PLANNING COMMISSION
Meeting Agenda
Monday – June 22, 2015
7:00 PM
City Council Chambers – 155 NW 2nd Avenue

a. *Consider a Planned Unit Development, Conditional Use Permit, and Site & Design Review applications to develop six residential duplex structures clustered around a private cul-de-sac for Hope Village (PUD 15-01, CUP 15-02, DR 15-02).*

SITE AND DESIGN REVIEW STAFF REPORT
FILE #: PUD 15-01, CUP 15-02, & DR 15-02
Prepared for the June 22, 2015 Planning Commission Meeting

SHEET TITLE:
LANDSCAPE PLAN

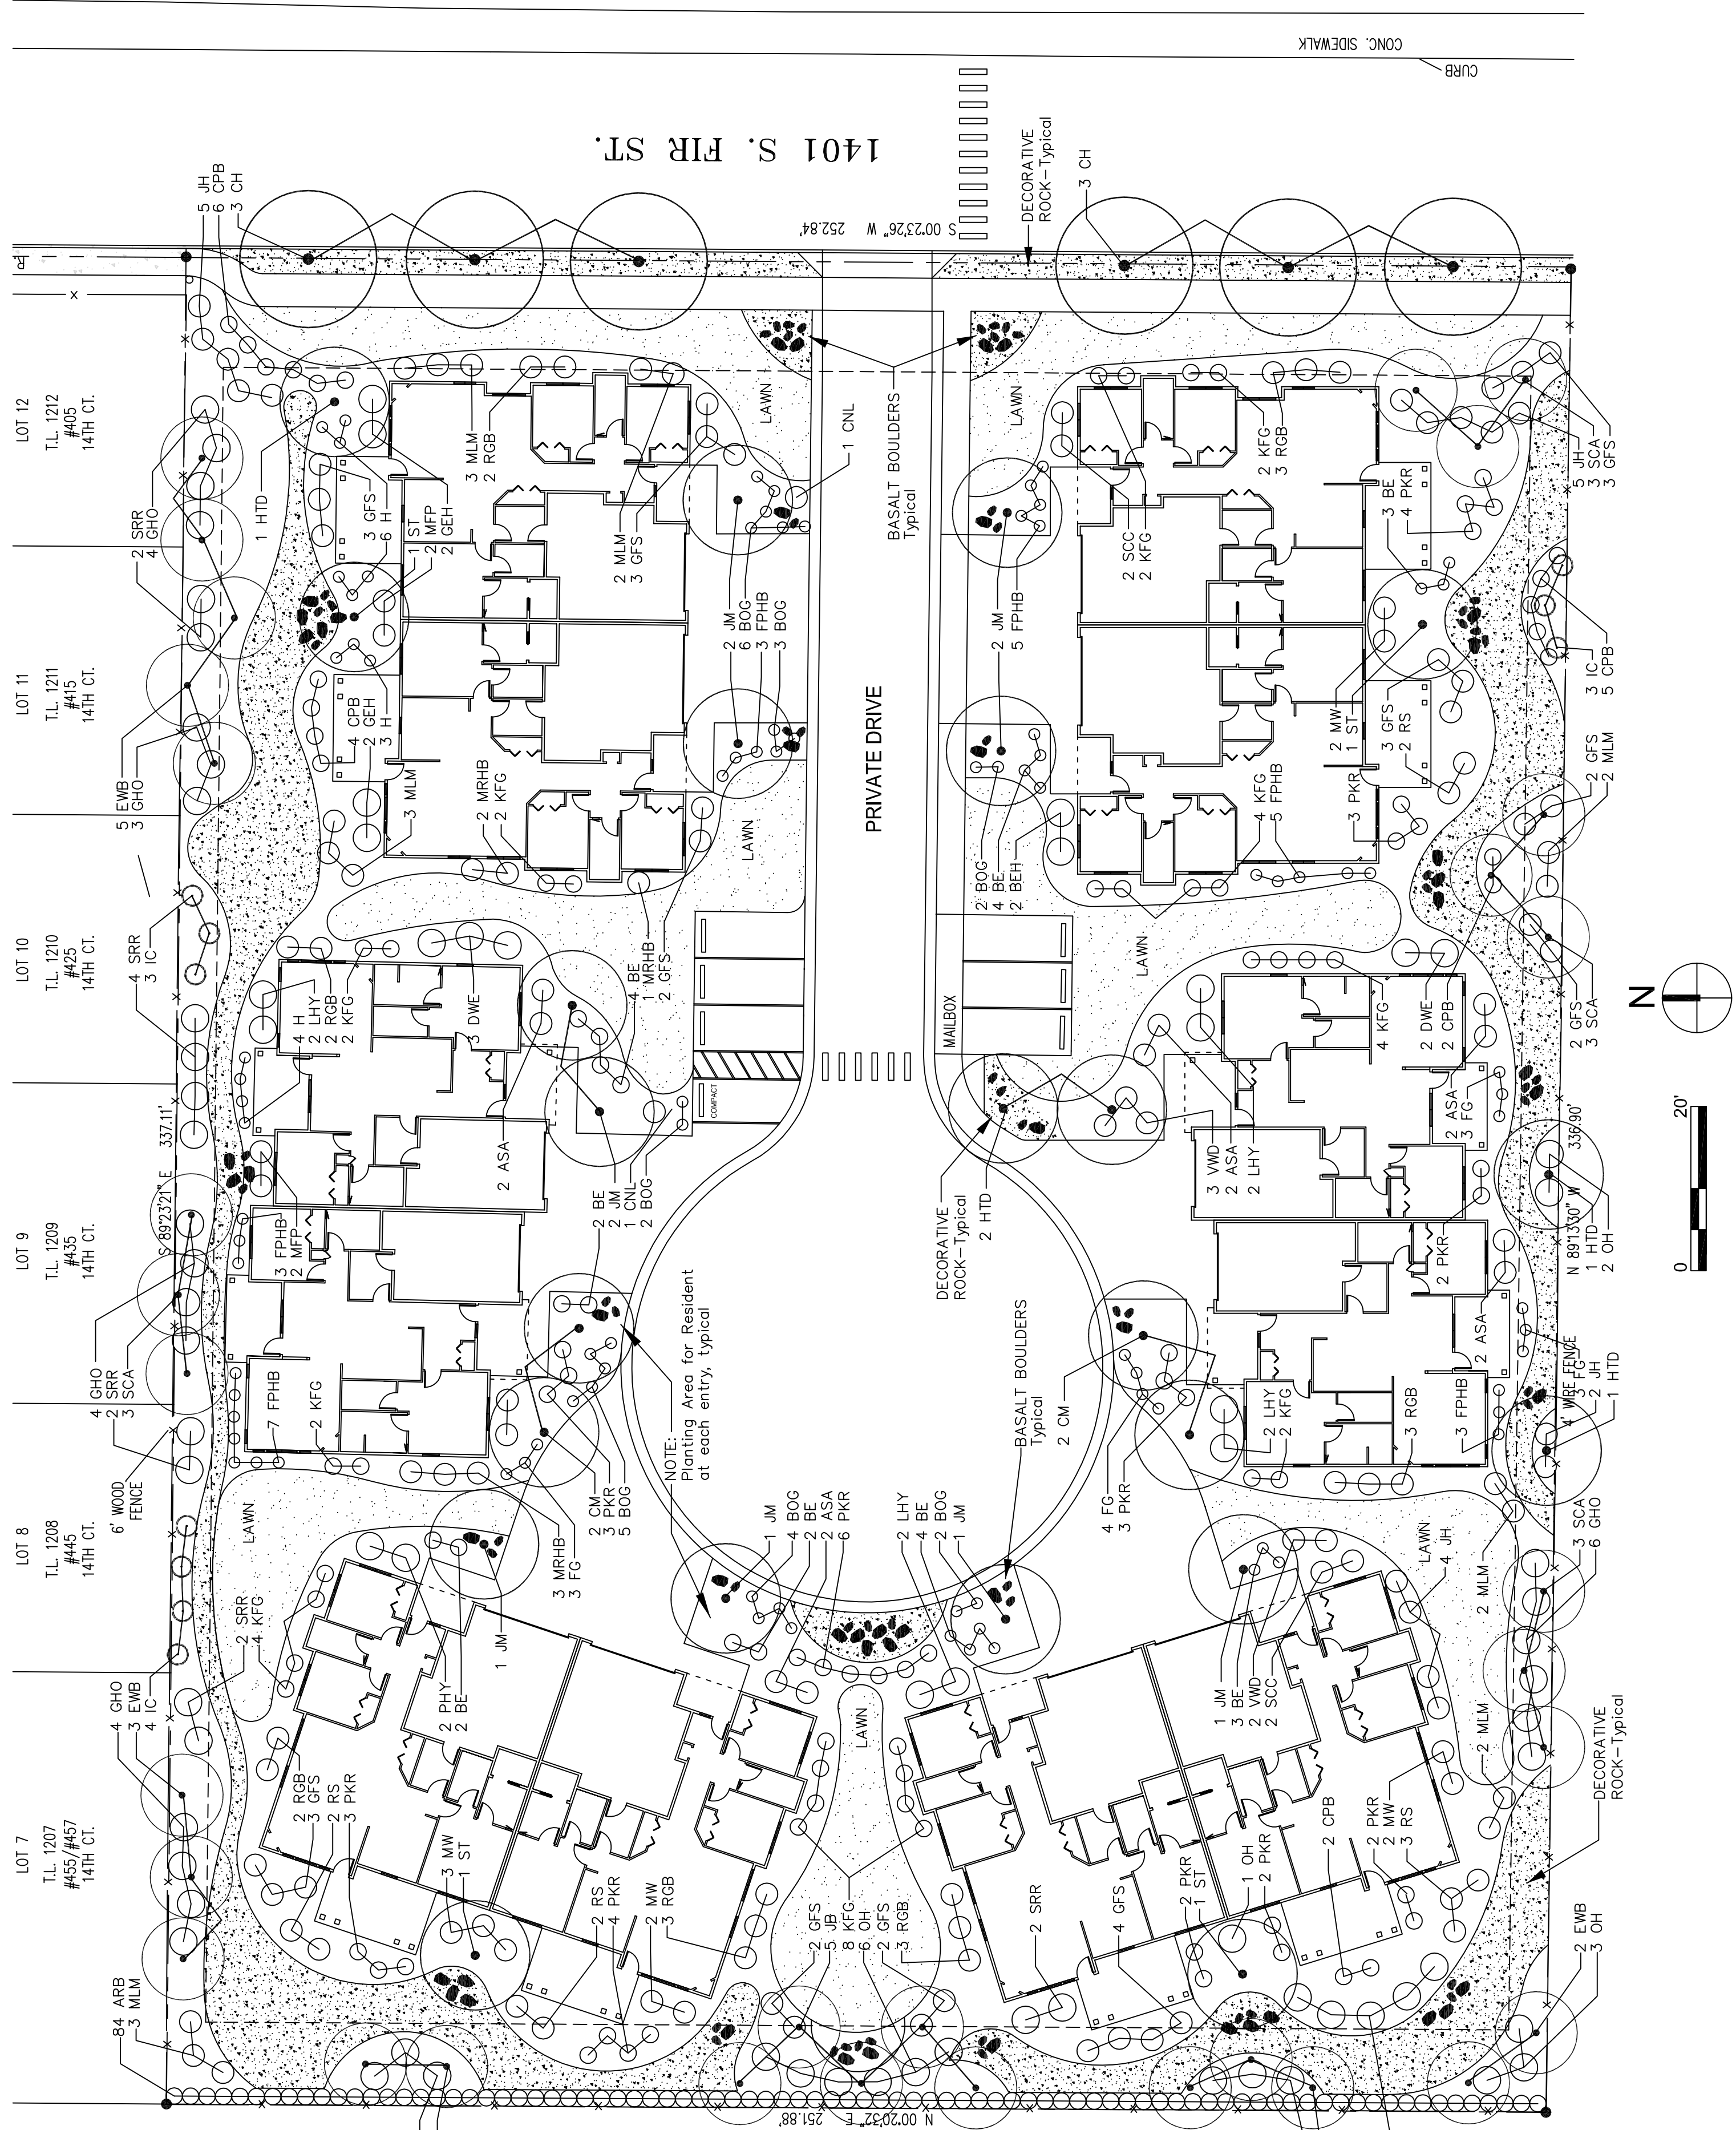
1. The applicant shall install the S Fir Street planter strip street trees as identified and indicated by the landscape plan (Sheet L.1) with the addition of a protective sidewalk barrier and shall be responsible for keeping them alive and healthy for the initial 2 year establishment period in place of payment of a City Street Fee authorized and otherwise used for residential subdivisions where landscape plans are not approved.
